April 18, 2017

ADDENDUM NO. 2

PROJECT: Wet Area Renovation at Prairie Stone Sports & Wellness Center
Hoffman Estates Park District
DLA Project No. 2017.08

WALL TYPE C
1 1/2" = 1'-0"

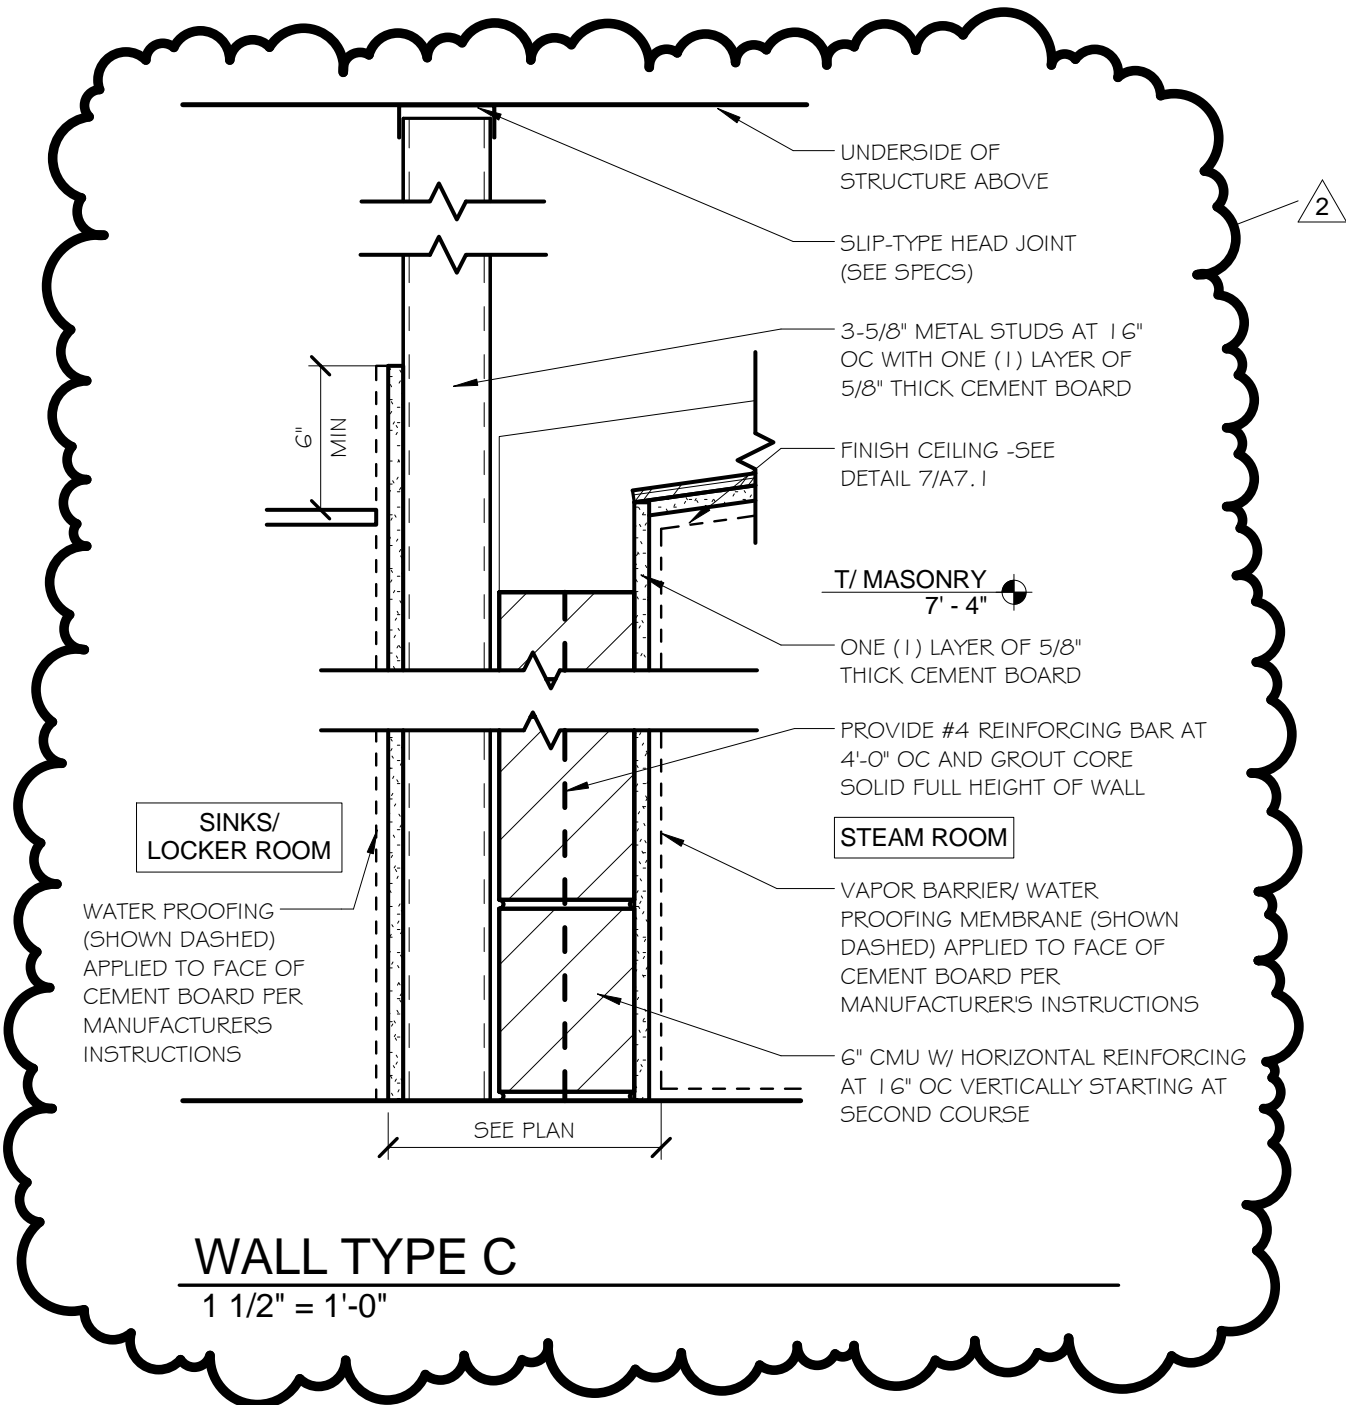
3. Sheet A7.1:
 - a. Wall Type C: Refer to attached re-issued sheet for modifications to this detail.
 - b. Detail 2: Revise the width of the two under-counter base cabinets to be 1'-7" wide, typical.

4 INTERIOR ELEVATION - STEAM ROOM
1/4" = 1'-0"

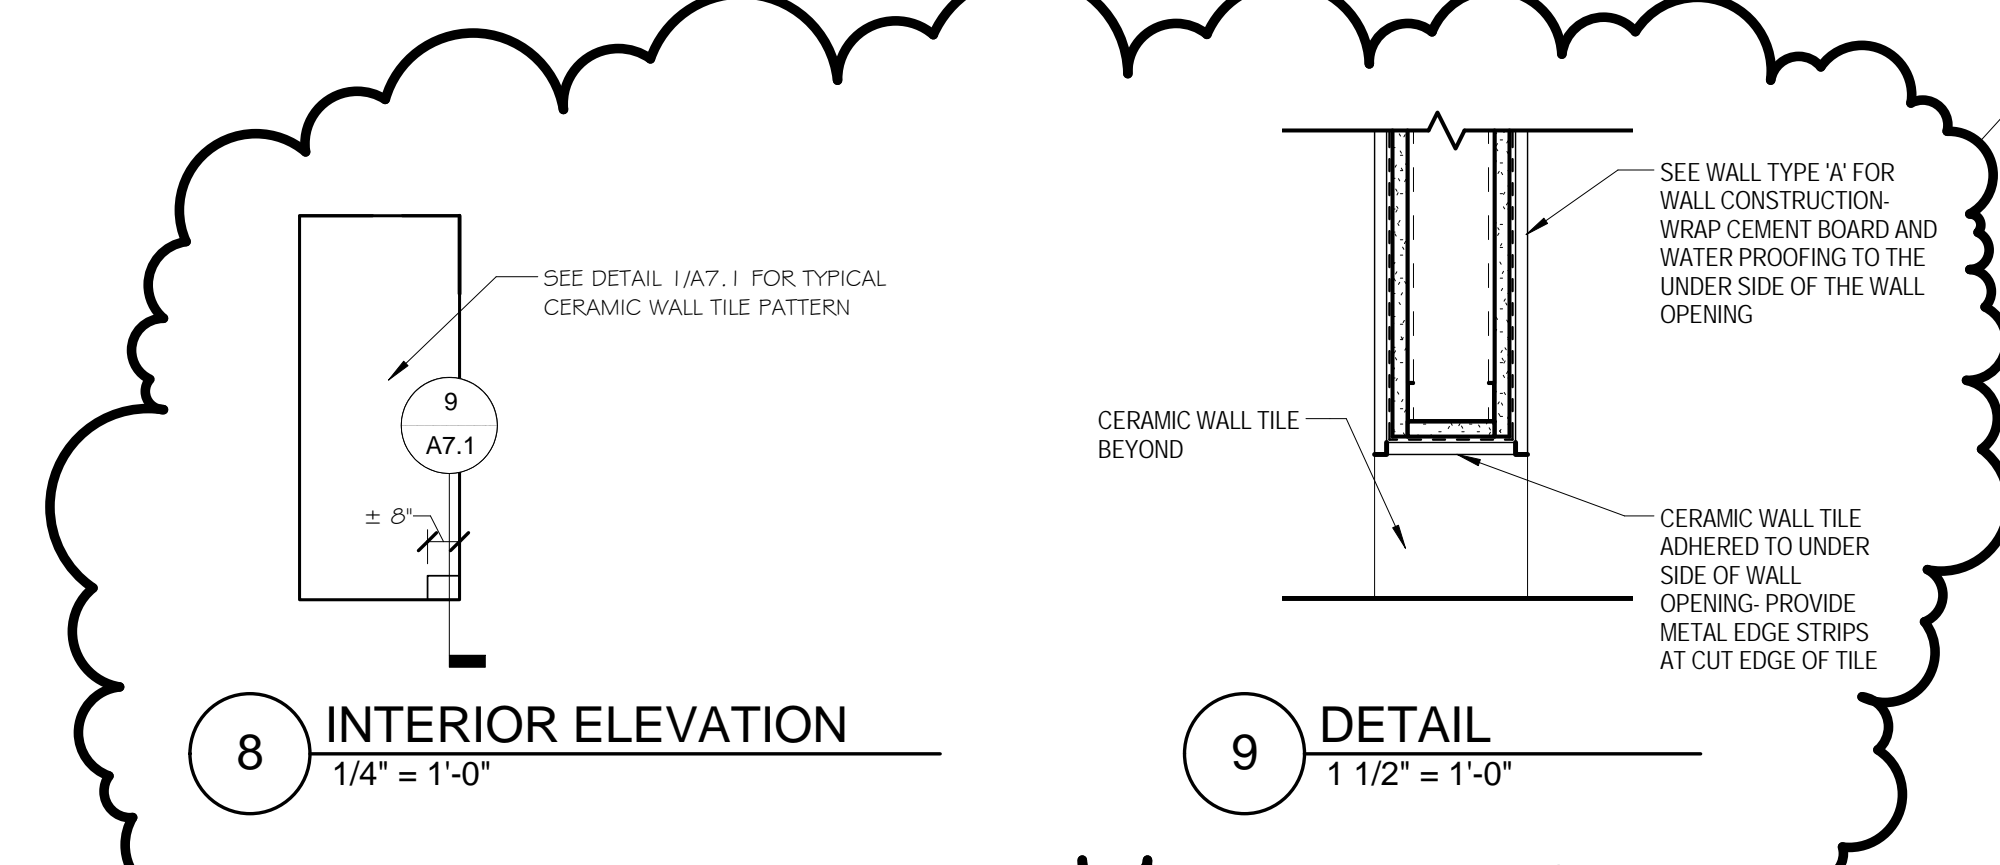
- c. Detail 4: Revise the Section Tag through the bench to read, "6/A7.1".
 - d. Detail 6: Refer to attached re-issued sheet for modifications to this detail.

9 DETAIL
1 1/2" = 1'-0"

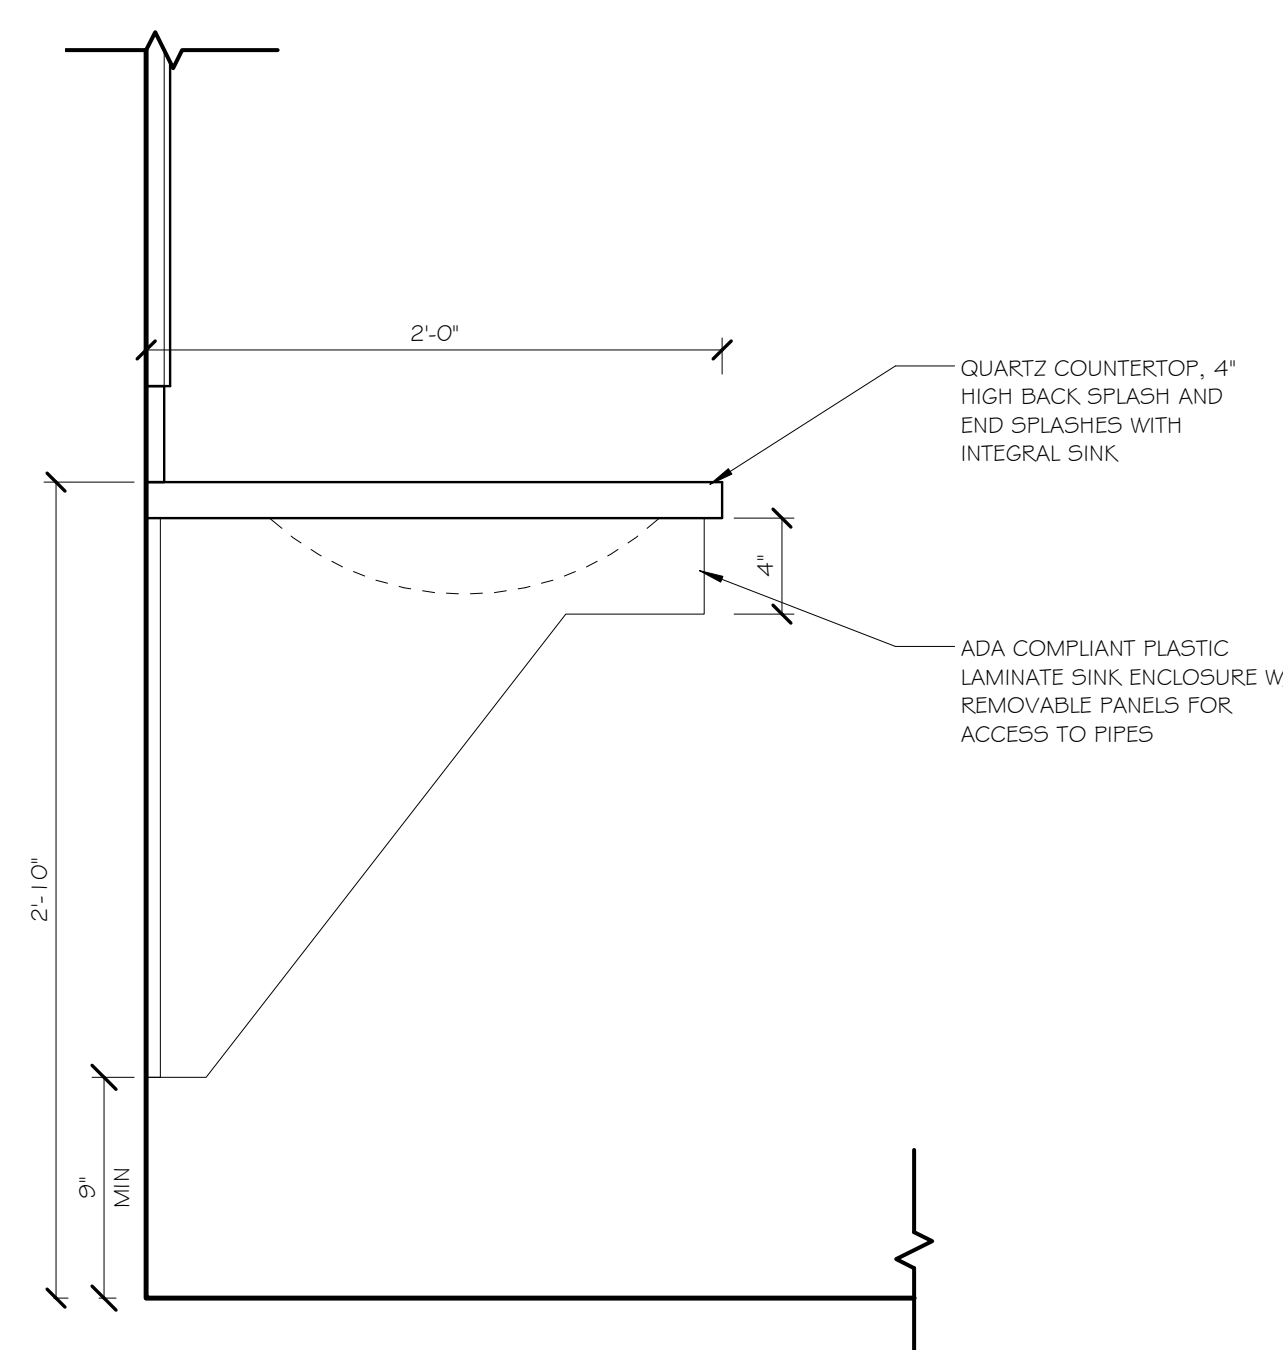
- g. Detail 9: Refer to the attached re-issued sheet for new detail cut at the side wall of the shower stalls.
4. Sheet A8.1:
 - a. First Floor Reflected Ceiling Plan: Refer to the attached re-issued sheet for clarification of the ceiling material in the Steam Rooms.

4 HEAD DETAIL- ALUMN
1 1/2" = 1'-0"

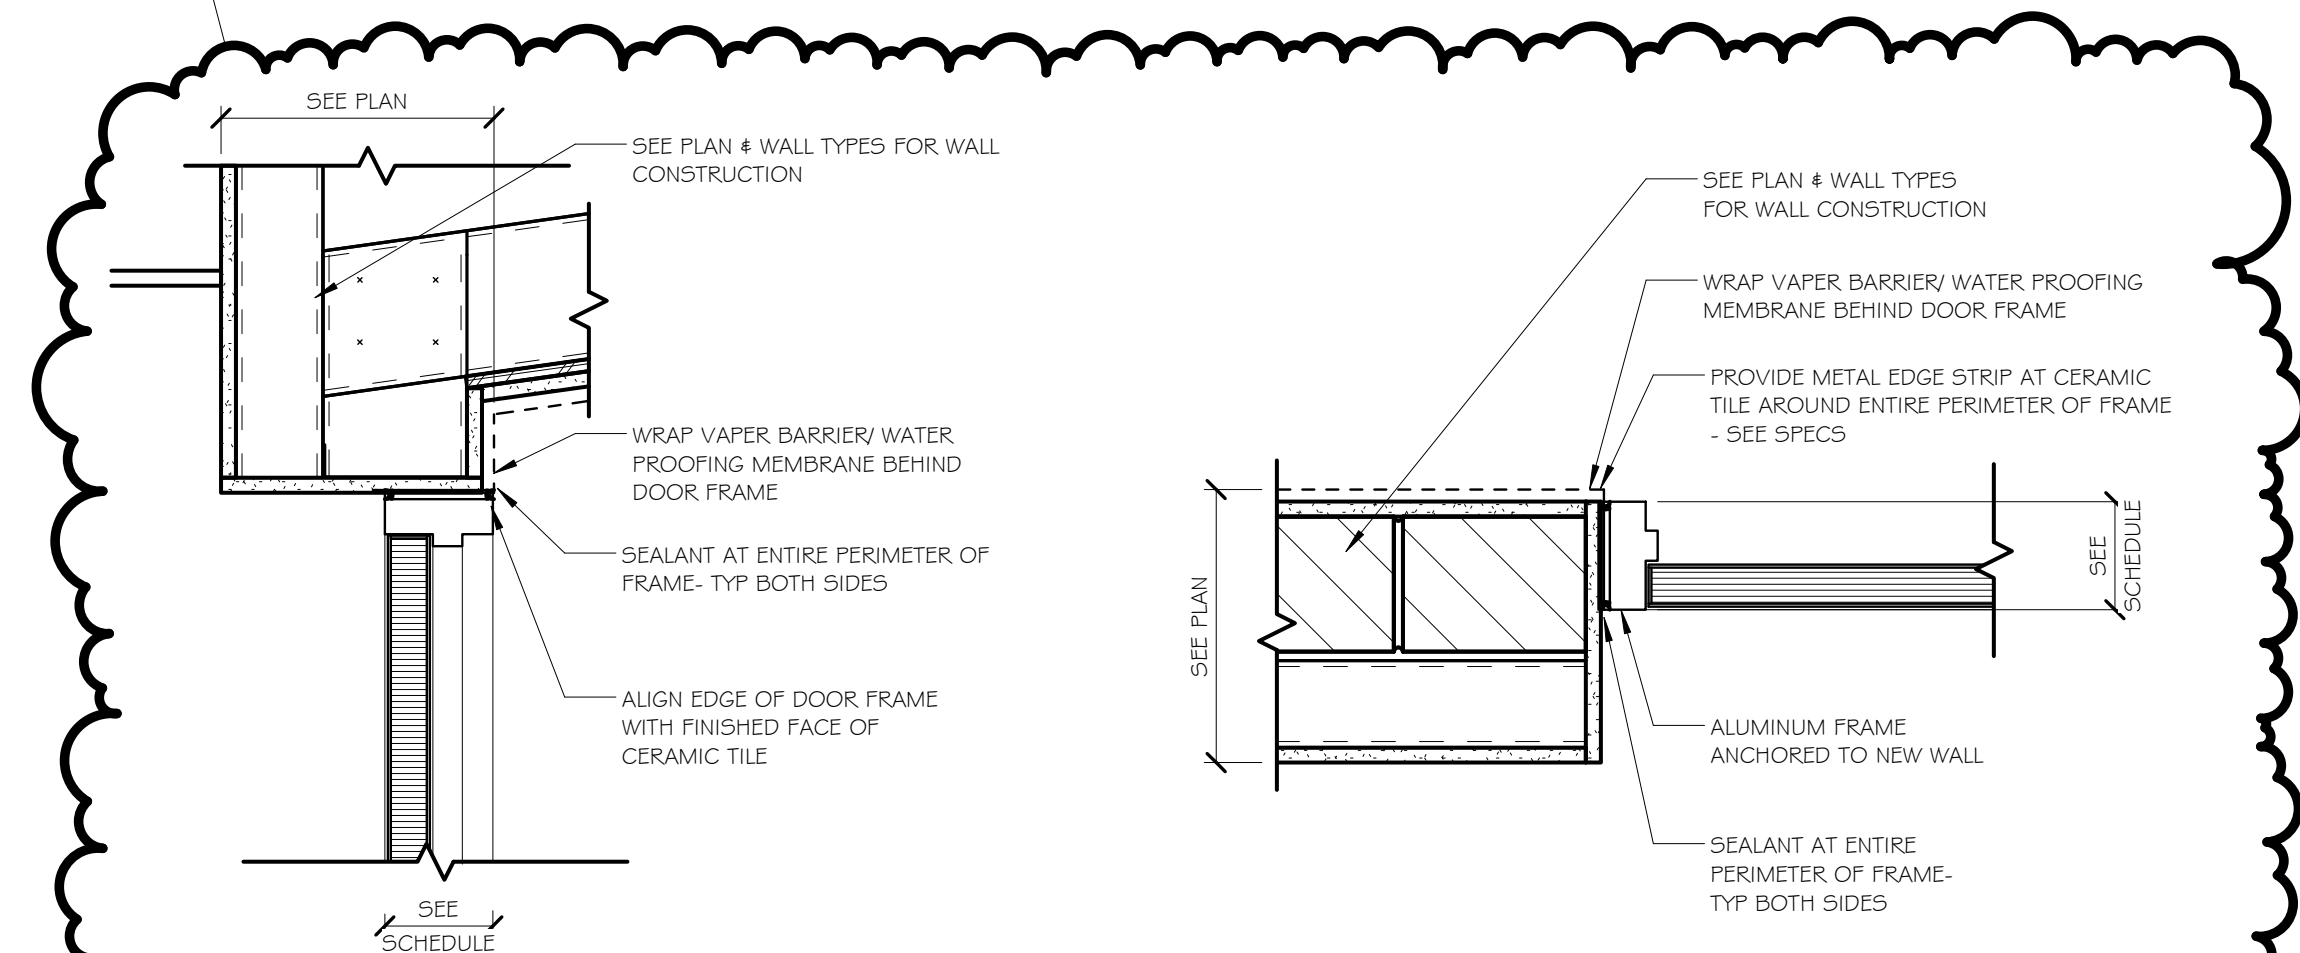
- b. Detail 4: Refer to attached re-issued sheet for modifications to this detail.
 - c. Detail 5: Refer to attached re-issued sheet for modifications to this detail.

1 FIRST FLOOR FINISH PLAN
1/4" = 1'-0"

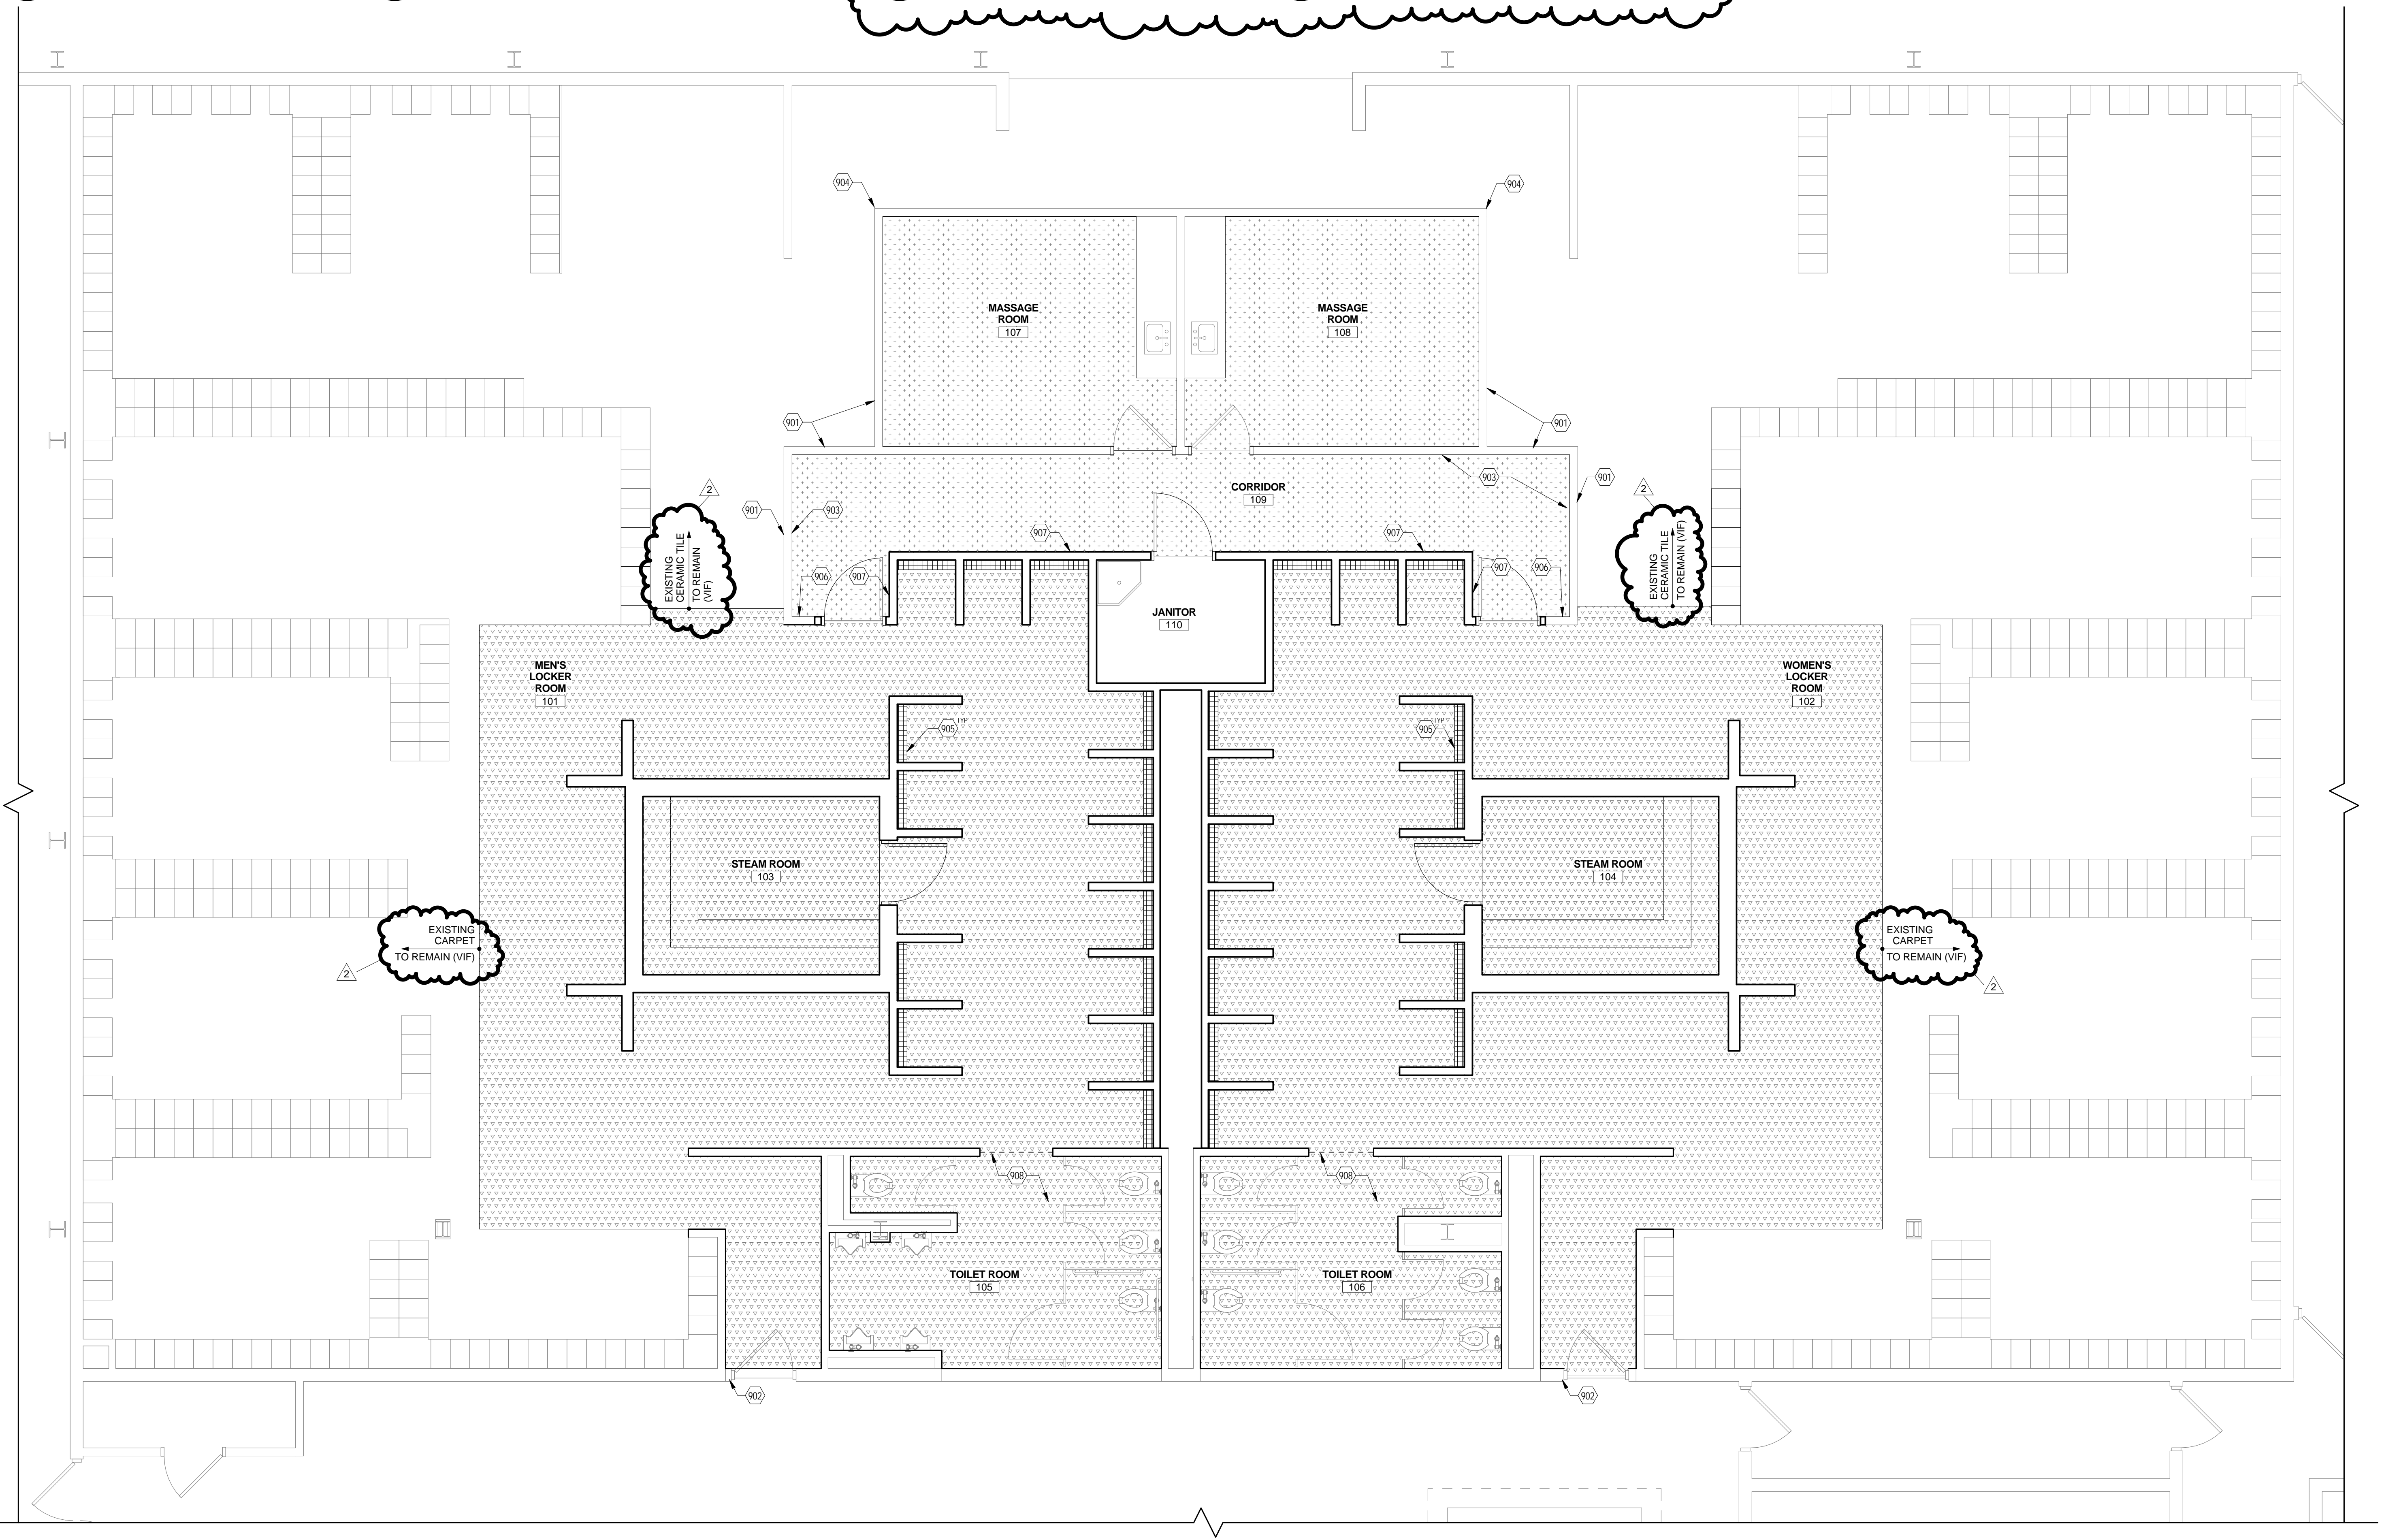
- b. Reflected Ceiling Plan Legend: Refer to the attached re-issued sheet for added material to the legend.
5. Sheet A9.1:
 - a. First Floor Finish Plan: Refer to attached re-issued sheet for added clarification about the existing floor material to remain.
